# Road Safety Audit Report

**Incorporating**  
**Stage 1/2 Completion of Detail Design;**  
Design Organisation Response to items raised.

## **Proposed Works to existing Public Footpaths through Meadow Gardens, North End Road Yapton**

| Document reference and revision:          | RSA-20-193-3                |

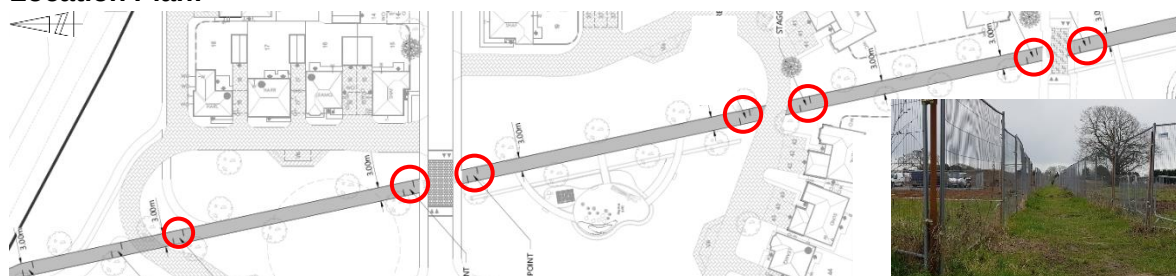
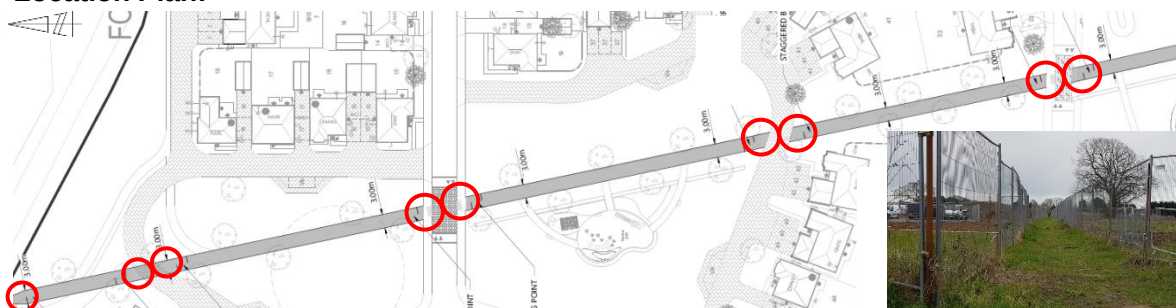
**B.2.2 PROBLEM**

**Location:** Scheme

**Summary:** Users will travel around the proposed staggered barriers on uneven ground

The existing footpath 357 that passes through a field to the east of North End Road and south of Ford Lane in an unmade and narrow route that is uneven in places. The proposals subject to this Stage 1/2 Road Safety Audit include the widening of the existing footpaths to 3 metres and the reconstruction with a 225mm base course below 75mm of dust and 100mm of limestone type 1 topped with 25mm of limestone dust which will provide an adequate surface that is cambered to ensure surface water drains to the soft verges either side that are detailed on the landscaping plans associated with the approved application Y/112/20/DOC. The current proposals illustrated on dwg ITB16479-GA-002 revision B included with the Audit Brief, identifies that staggered barriers are to be provided adjacent to all locations where the public right of way crosses the on-site roads. The scheme drawing also identifies that raised tables or shared surface areas are to be provided where the footpath crosses the on-site roads and the landscaping plans indicate that the crossings are to be fairly open with no high-level planting provided in close proximity. Whilst staggered barriers assist in slowing users to ensure that they proceed with caution, users tend to bypass the measures if a route is available. It is therefore likely that users of the public right of way, will bypass the staggered barriers on the adjacent soft verge which is likely to become uneven as a result of use particularly during inclement conditions. An uneven surface could give rise to trips, falls and personal injury.

It is recommended that the staggered barriers are replaced with bollards that include reflective features to reduce the likelihood of users bypassing the surfaced route and crossing at a location away from the dropped kerb crossing points that benefit from tactile paving.

| Accepted – the staggered barriers have been removed from the internal aspect of the layout and replaced with bollards. The bollards are to be fitted with reflective material, and also incorporate way-finding for the Public Right of Way.                                                                                                                                                                                                                                                                                                                                                                                                                                                                                                                                                                                                                                                                                                                                                                                                                                                                                                                                                                                                                                                                                                                                                                                                                                                                                                                                                                                        |                                                                                   |

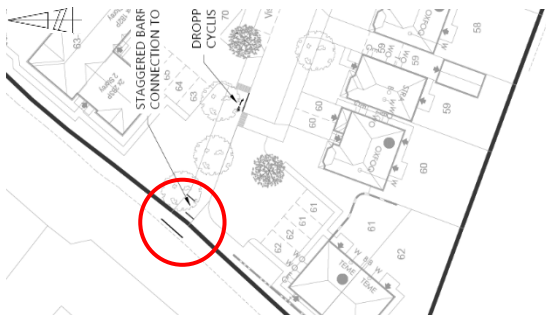
**B.4.2 PROBLEM**

**Location:** North End Road

**Summary:** Cyclists and pedestrians may not be aware of one another

The proposals that are subject of this Stage 1/2 Road Safety Audit include the provision of a surfaced 3 metre route for pedestrians through a proposed residential development that is lightly trafficked and accommodates a network of footways alongside the on-site roads. The scheme drawing provided with the Audit Brief, identifies that whilst pedestrian access to the site can be gained via connections to Public Right of Way 358 to the northeast, 358, 359 and to the south, and 357 to the northwest, a new link is to be provided to the via a shared footway cycleway facility to North End Road to the west. Hazard warning tactile paving is to be provided where the proposed on-site footways meet the shared facility allowing pedestrians travelling from the development to become aware of the change in use and potential for cyclists, however, no tactile warning surface is provided where the shared facility crosses the existing North End Road footway. Furthermore, no facilities are provided to allow cyclists level access between the shared footway cycleway and North End Road carriageway. The lack of tactile warning surface along the existing footway could give rise to pedestrians, particularly the visually impaired, walking into the path of cyclists without warning and the lack of measures to allow level access between the carriageway and shared facility, could lead to cyclist falls.

It is recommended that a hazard warning tactile surface is provided in accordance with national guidelines

| <p>Accepted – a Section 278 Agreement has been entered into for works to be undertaken on the highway outside of the redline boundary. However, corduroy paving and end of route signage has been incorporated into the revised design ITB14679-GA-002 Rev C.</p> |                                                                                                                       |
